Addendum No.: 2

York Correctional Institution Central Plant and Piping Distribution

BI – JA – 465

The following clarifications are applicable to drawings and specifications for the project referenced above.

**6 HEAT TRACING DETAIL AT ENCLOSURES**

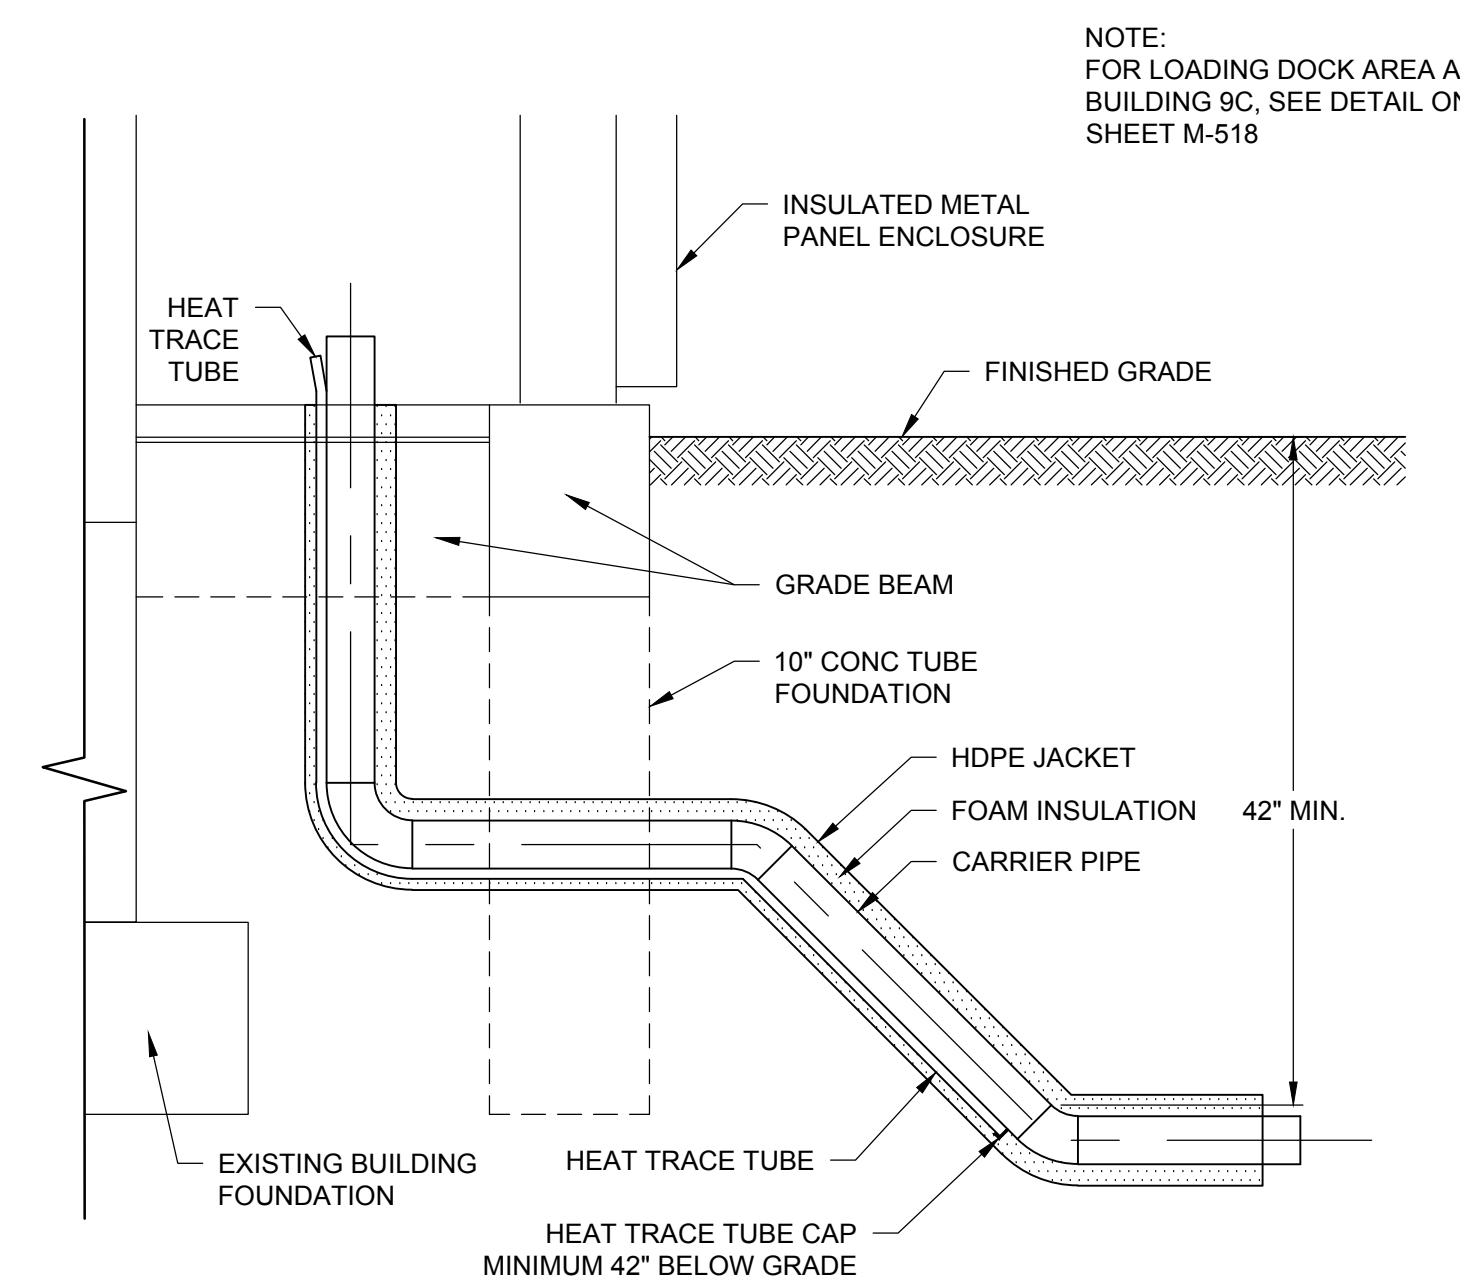
**UPDATED** detail 6 title for clarity.

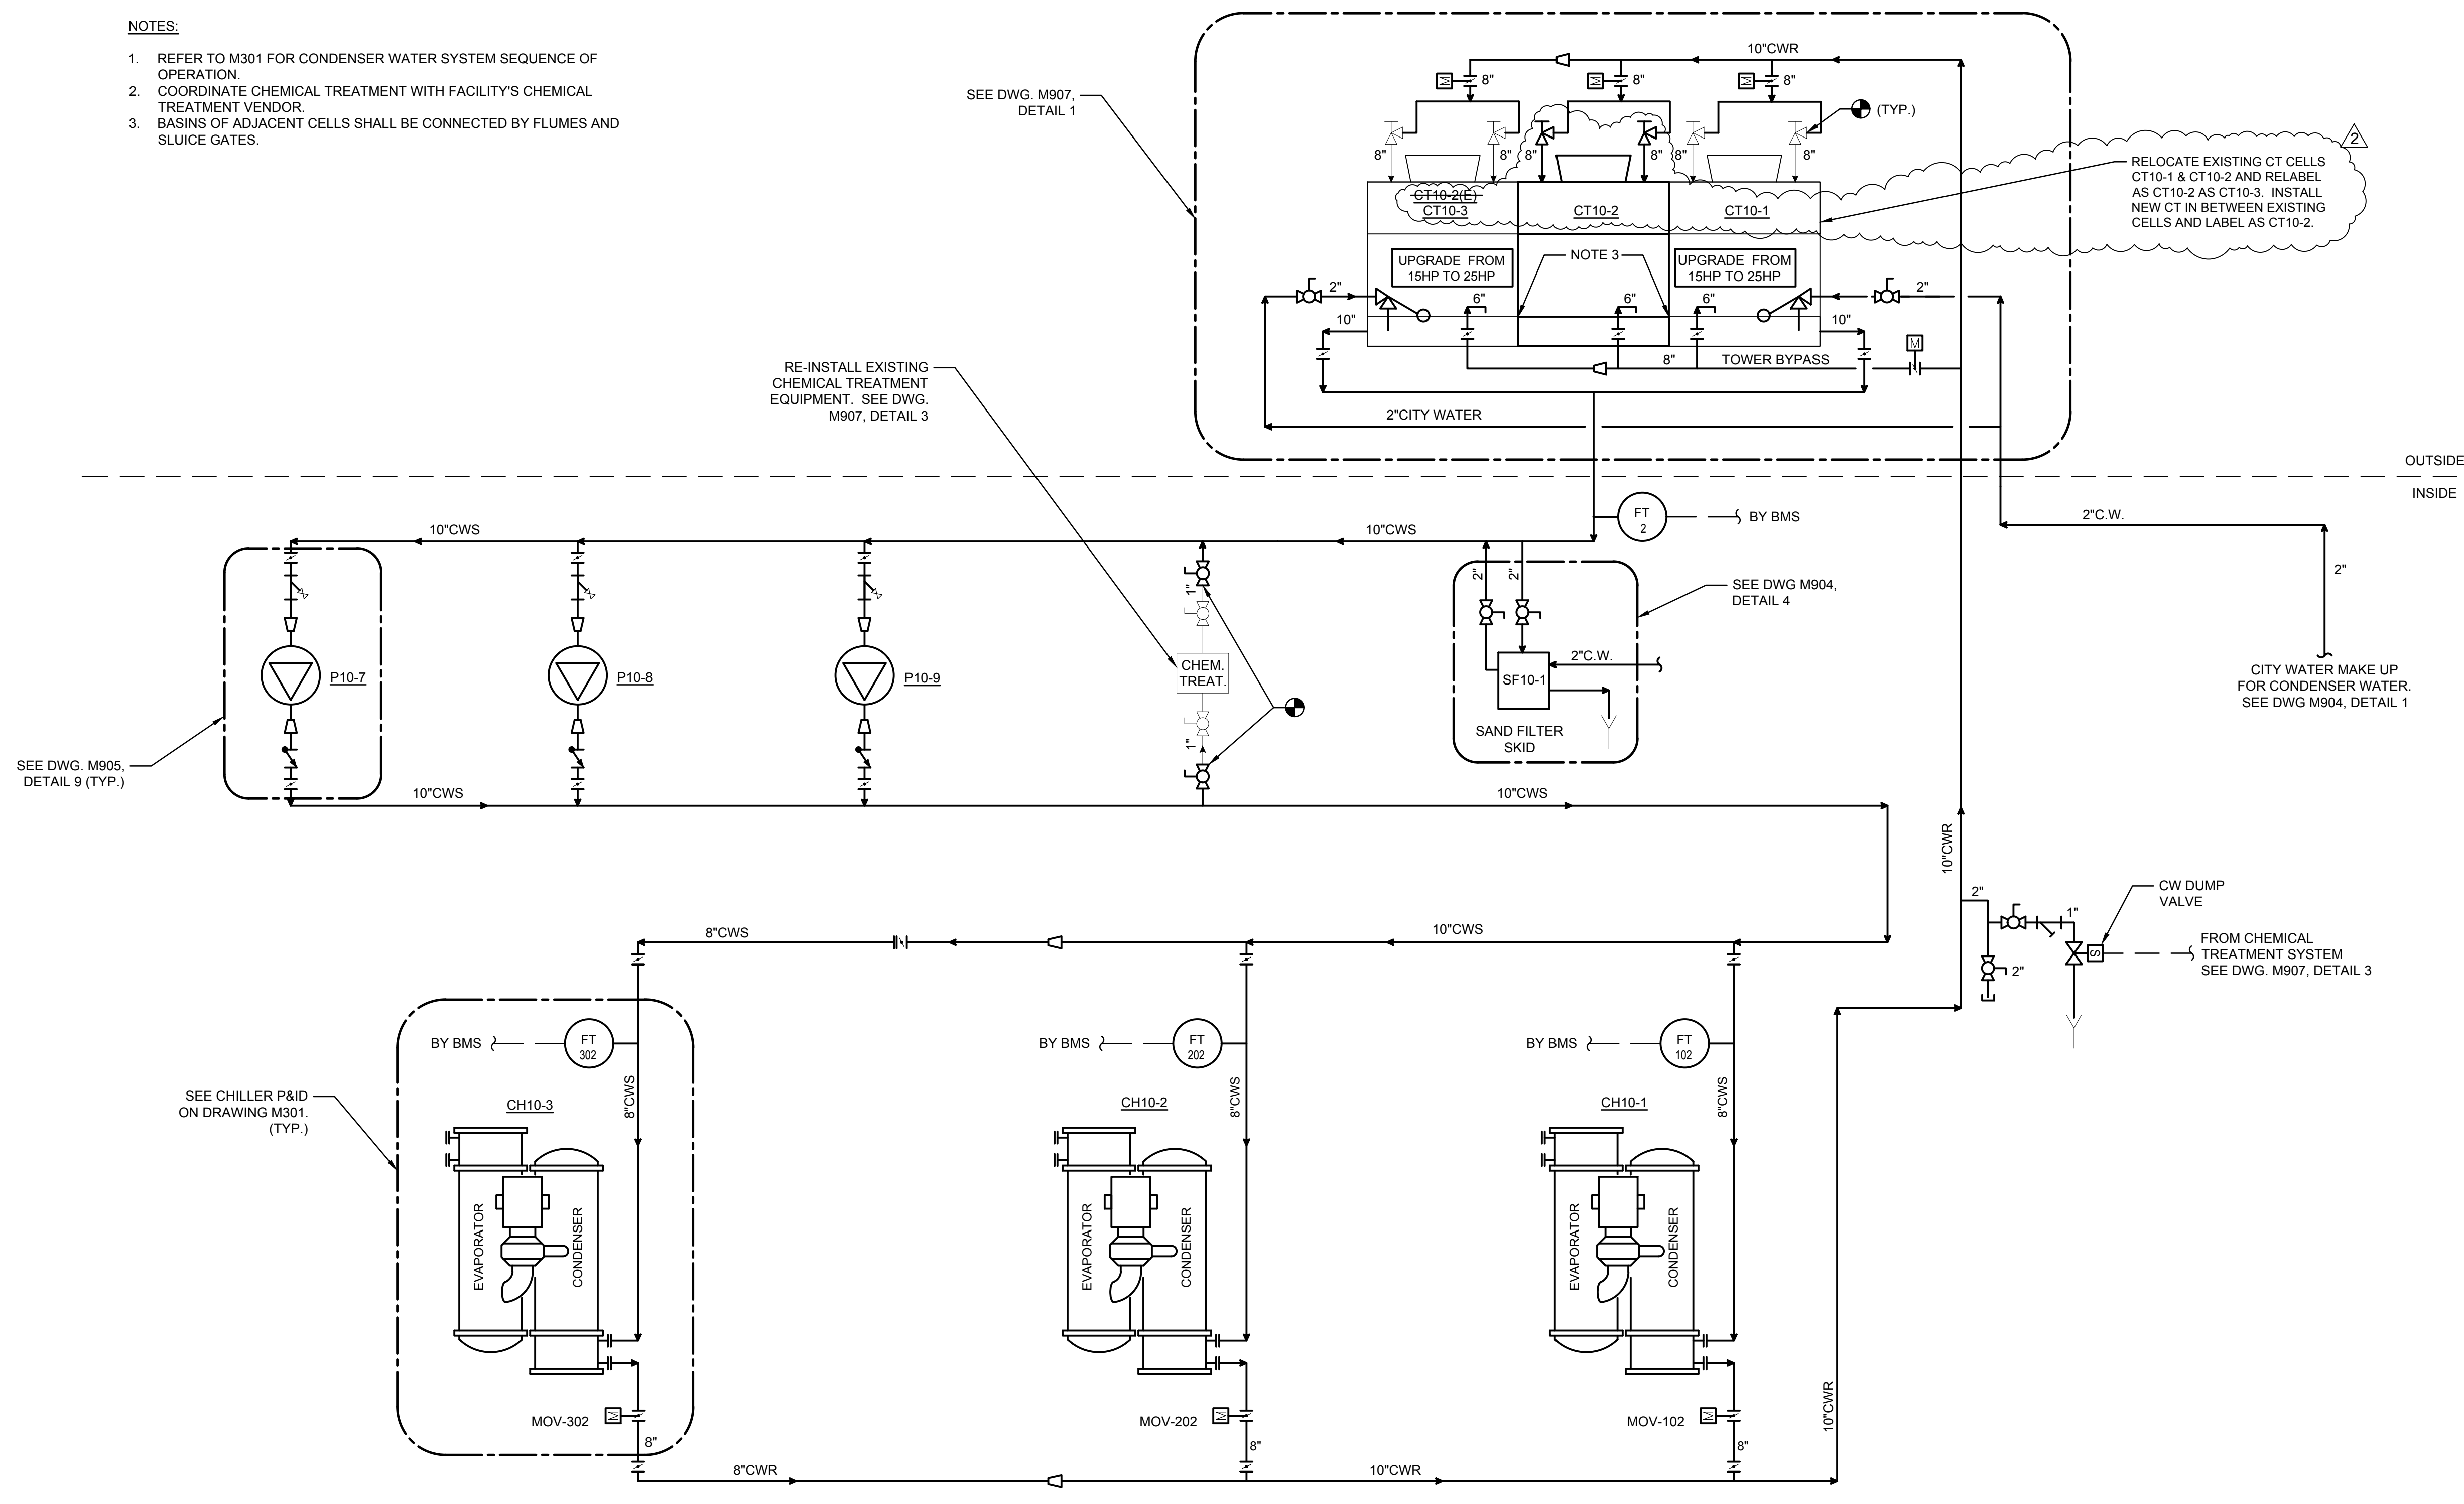
Drawing M204 Plant Condenser Water Flow Diagram Installation

**REPLACE** the entire drawing with the attached.

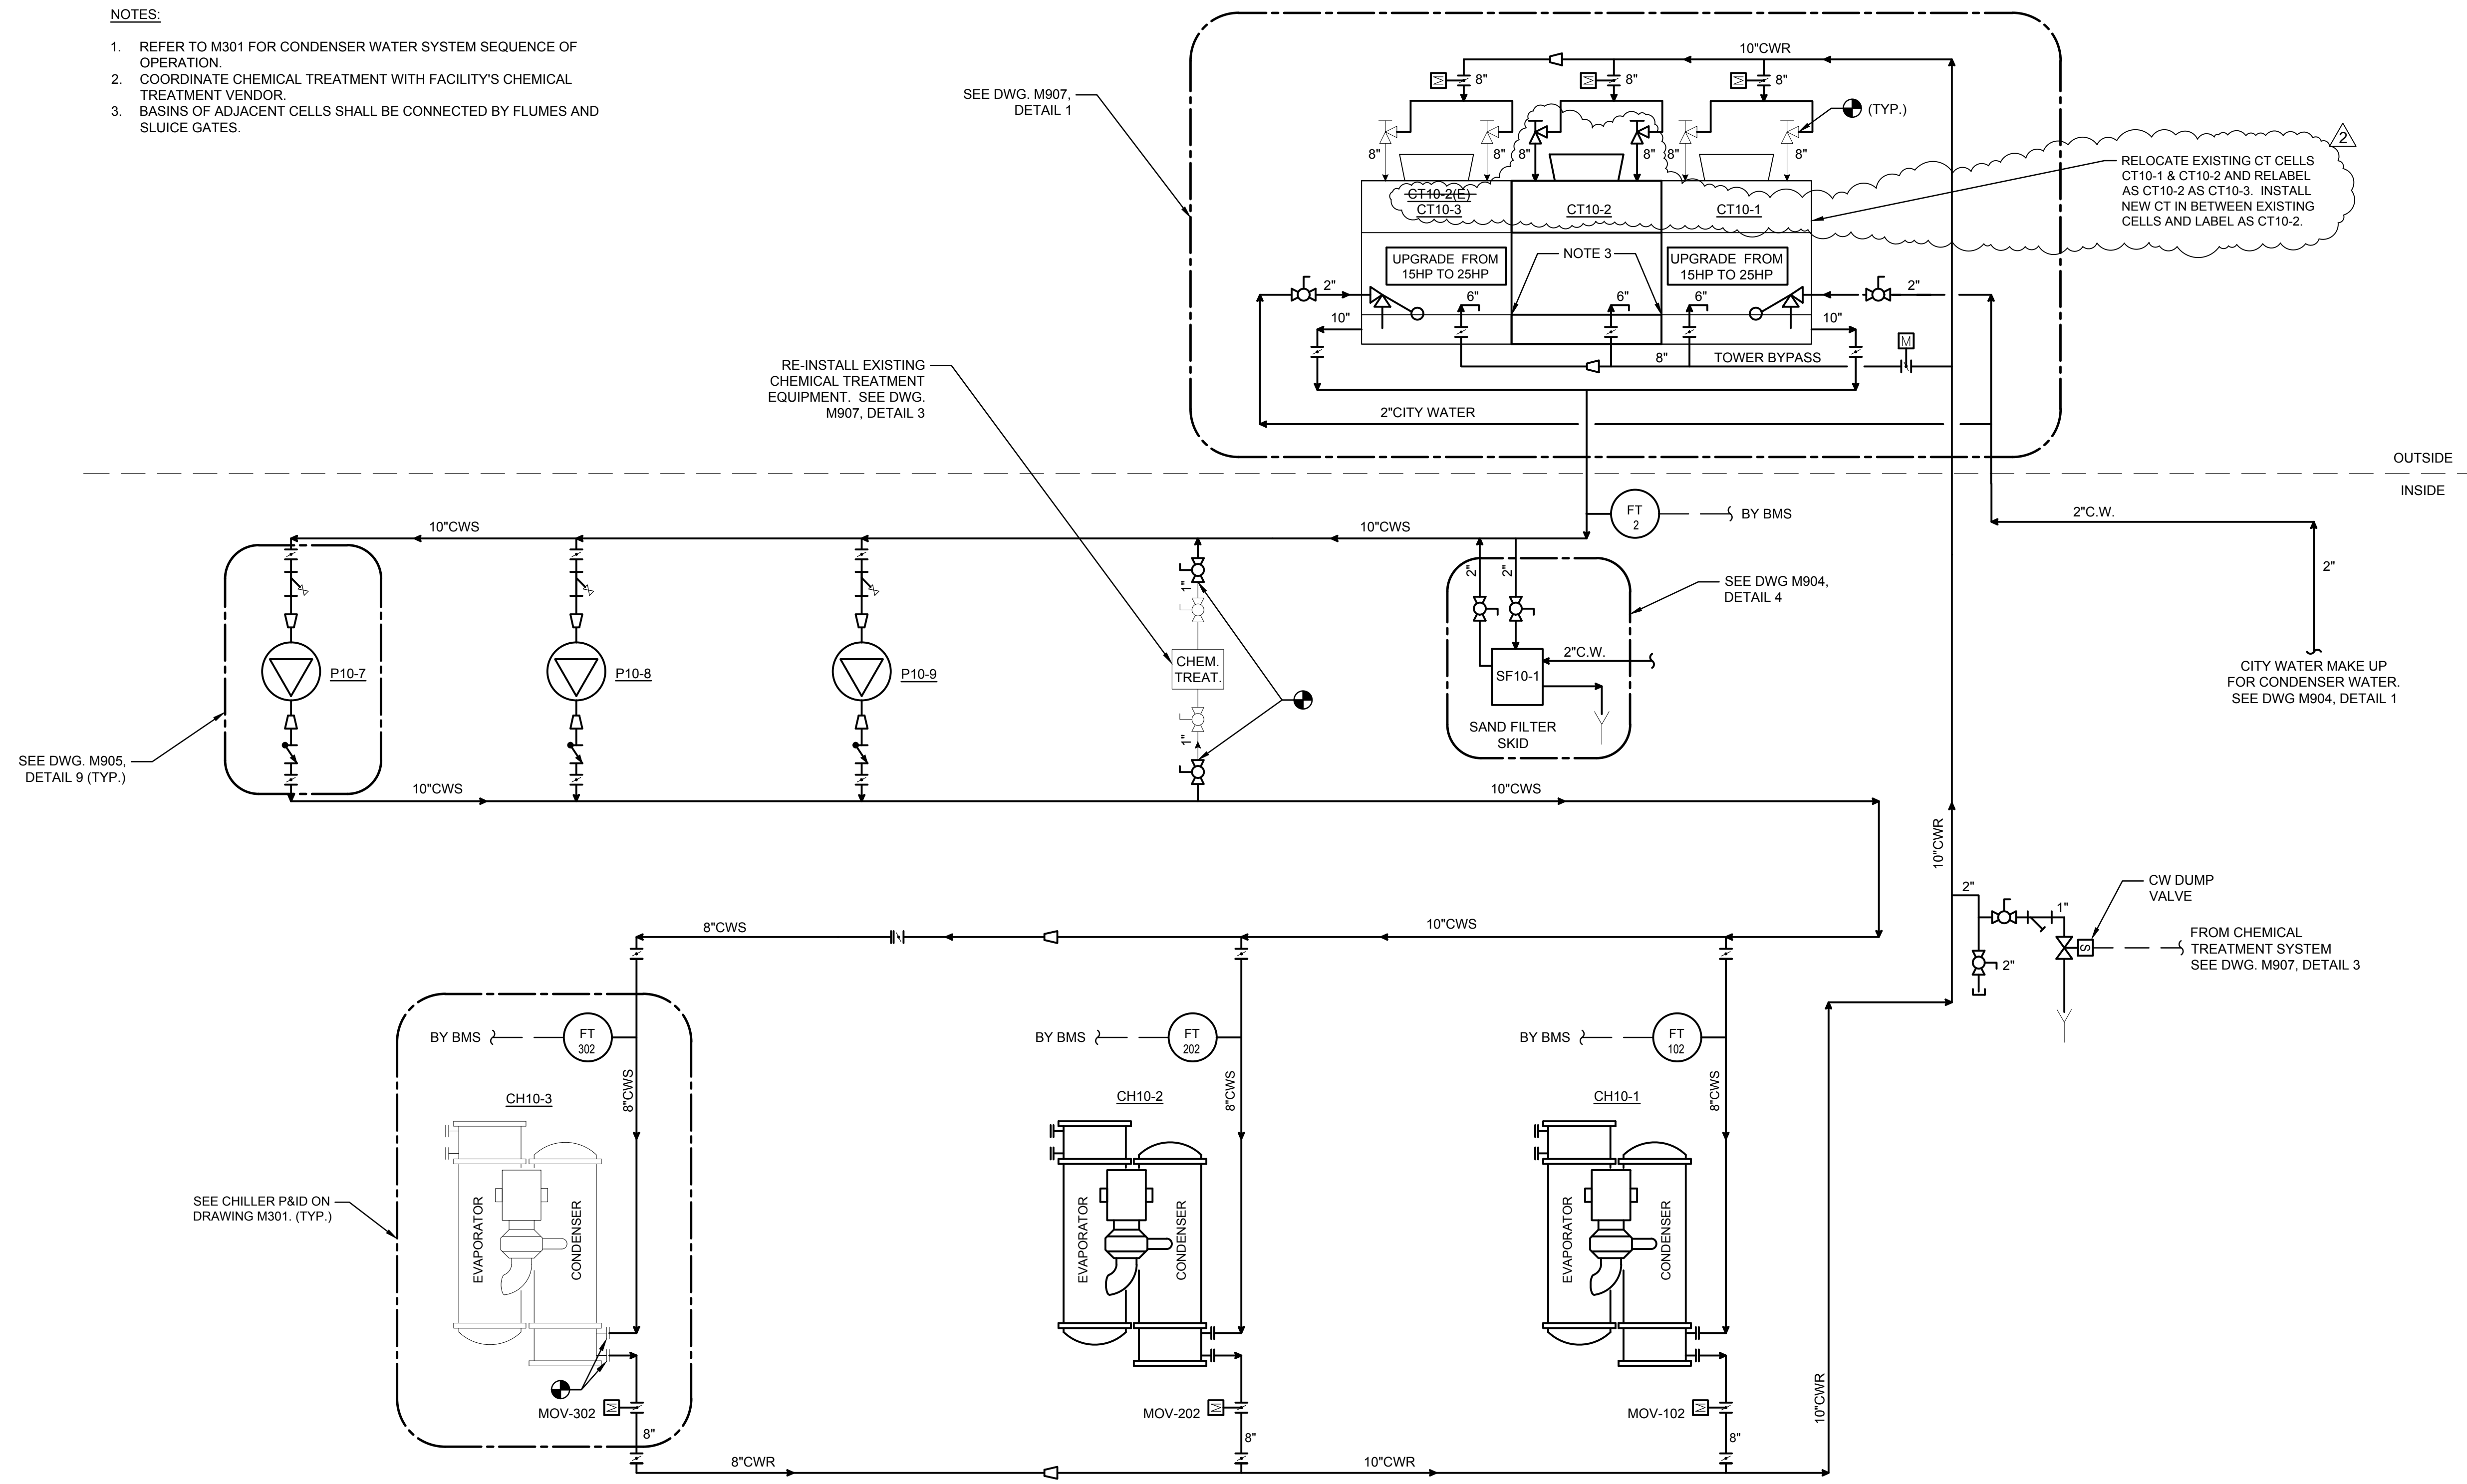
Drawing M406 Plant CW Flow Diagram Installation Phase 5

**REPLACE** the entire drawing with the attached.
